- 4. Sheet A100R3 FIRST FLOOR REMODEL PLAN - SEG A 30 x 42 attached hereto
 - a. Revisions clouded on Drawing
- 5. Sheet A103R1 SECOND FLOOR REMODEL PLAN - SEG B 30 x 42 attached hereto
 - a. Revisions clouded on Drawings
- 6. Sheet A601R2 DOOR SCHEDULE 30 x 42 attached hereto
 - a. Revisions clouded on Drawings
 - b. Door 224 removed from project
 - c. 1H2 changed from side coiling door to standard 3'-0" door

END OF DOCUMENT 00 90 00

Project Title: **WESTERN TECHNICAL COLLEGE
ARC & WELCOME CENTER PHASE 2 REMODEL**
Project Location: 400 N. 7TH STREET
LA CROSSE, WI 54601
Sheet Title: **FIRST FLOOR REMODELED PLAN - SEG A**

SECOND FLOOR LOW VOLTAGE PLAN

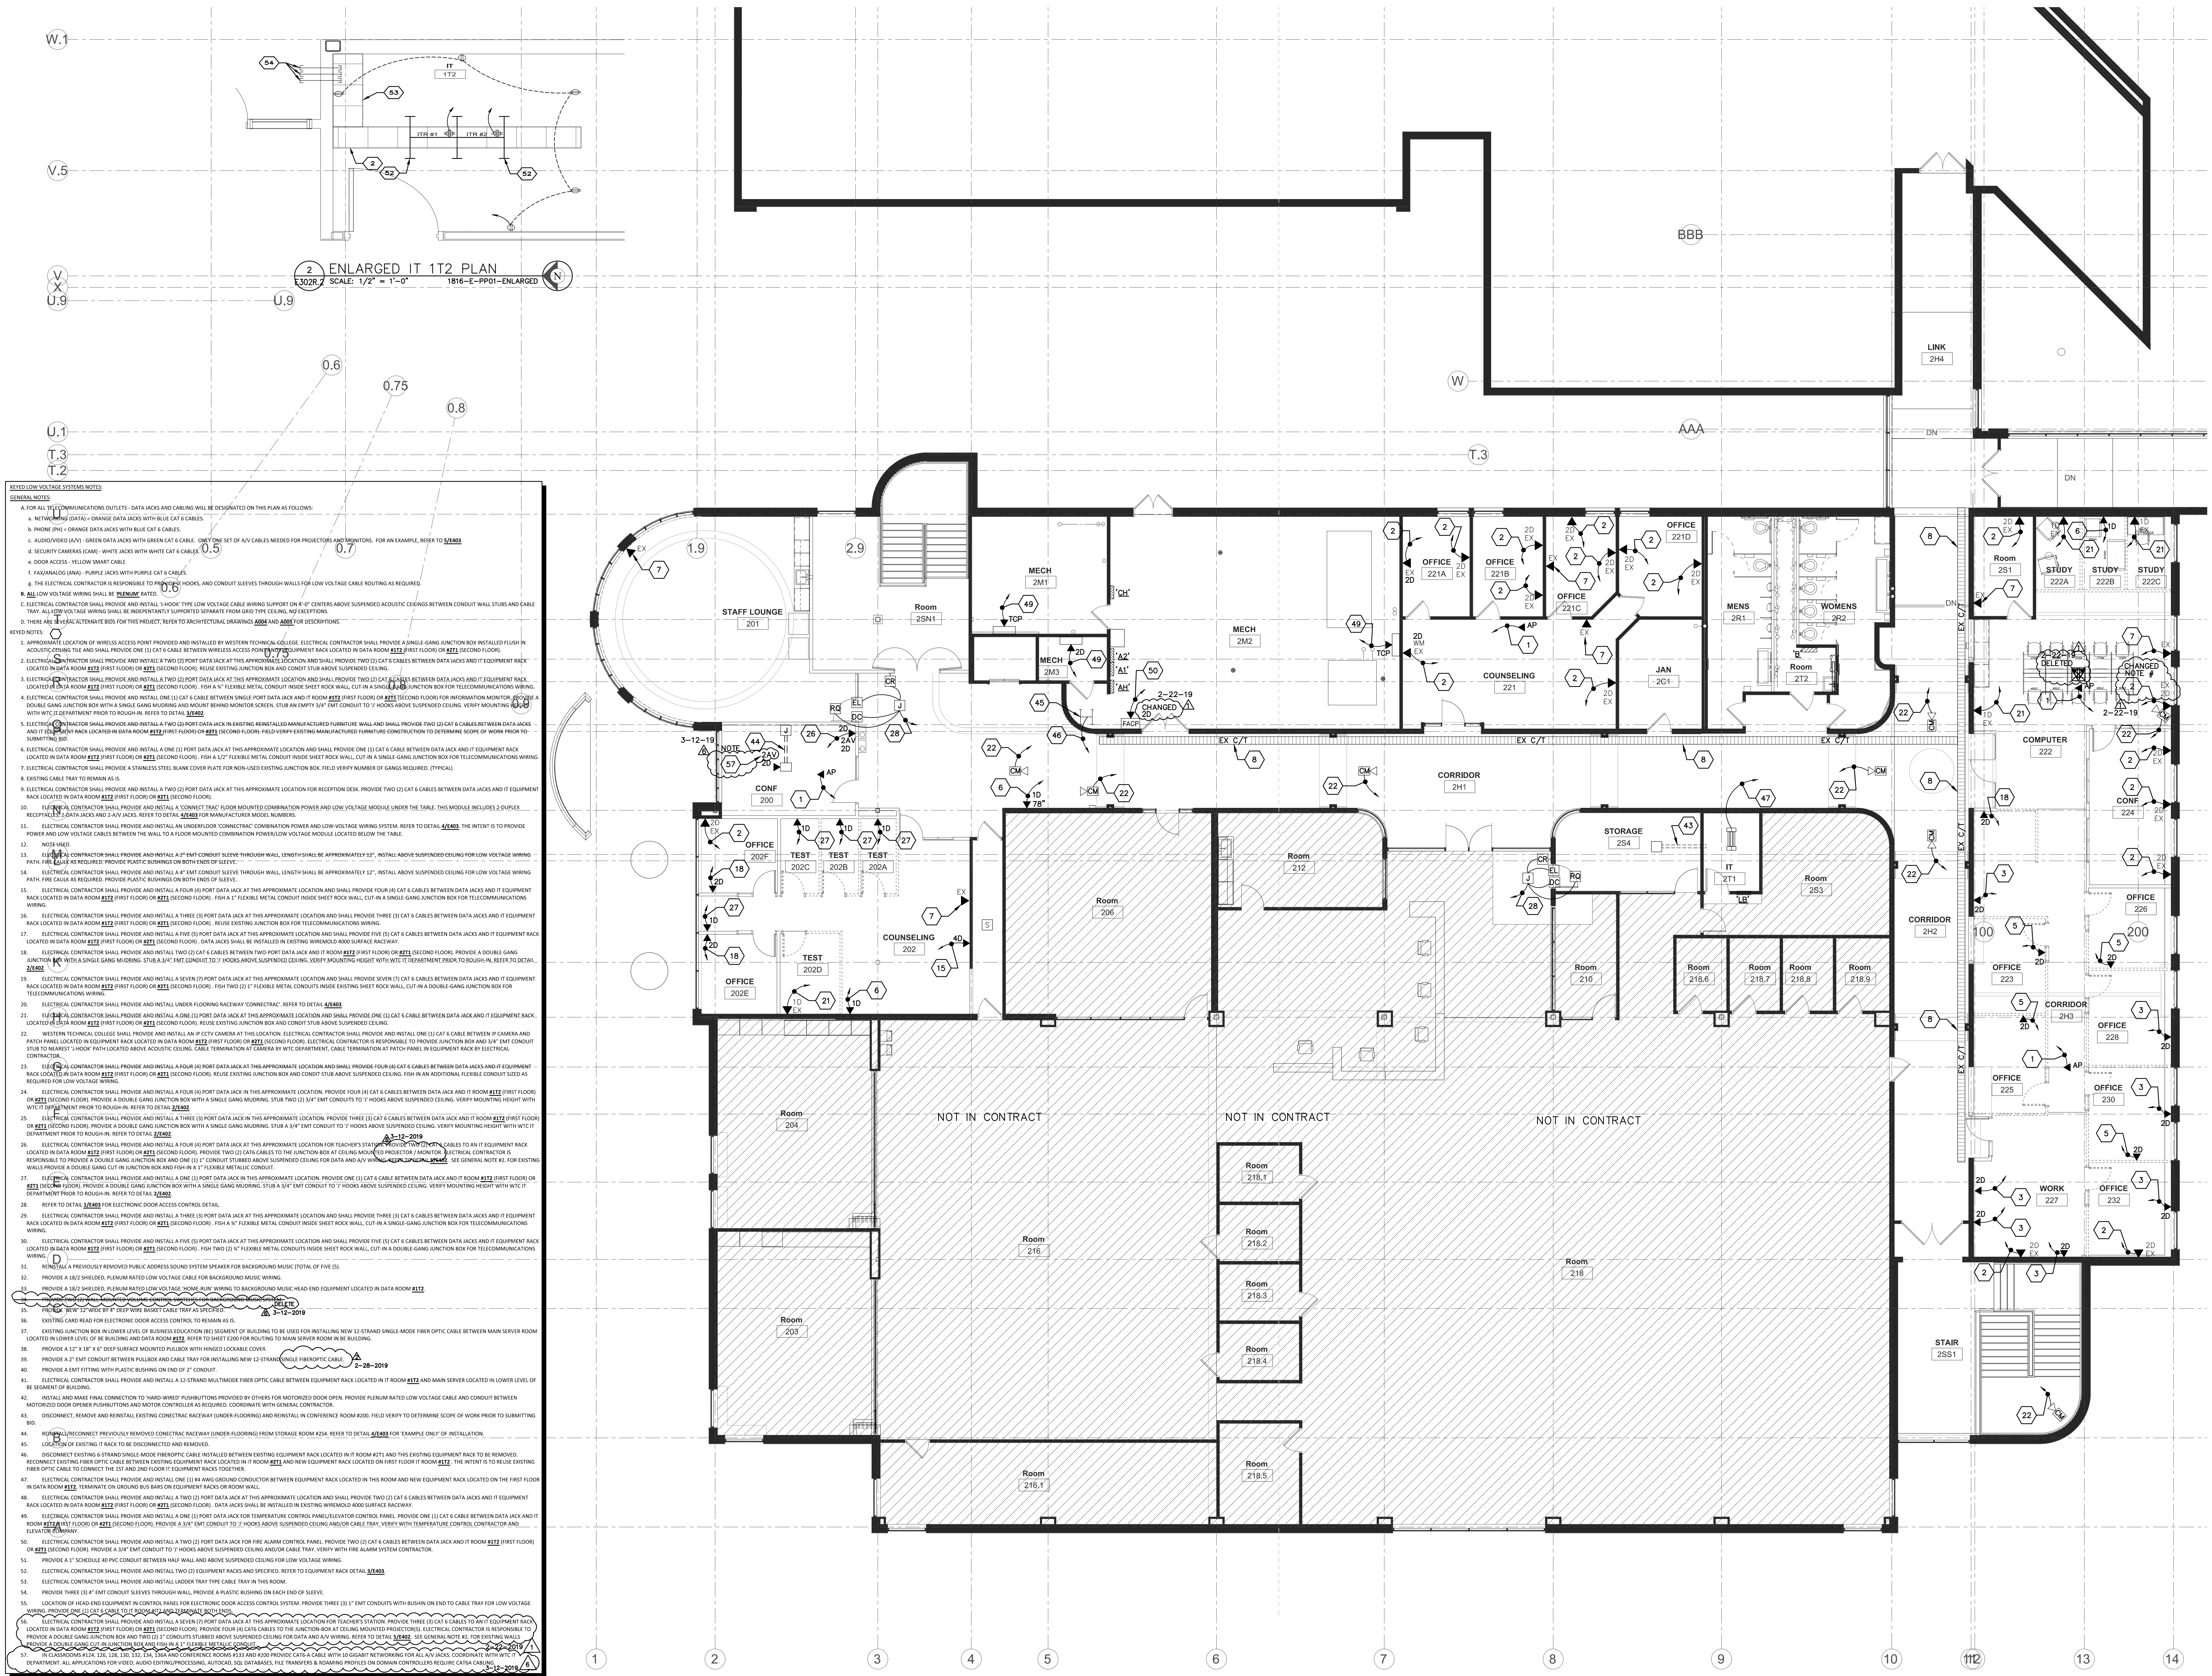
20. Sheet E302R2 PARTIAL SECOND FLOOR LOW VOLTAGE PLAN 30 x 42 attached hereto
 - a. Drawing added to Contract documents
 - b. In conference room #200 provide CAT6-A cable with 10 Gigabit networking for all A/V jacks. Coordinate with WTC IT department. All applications for video, audio editing/processing, AutoCad, SQL databases, file transfers & roaming profiles on domain controllers require CAT6A cabling.
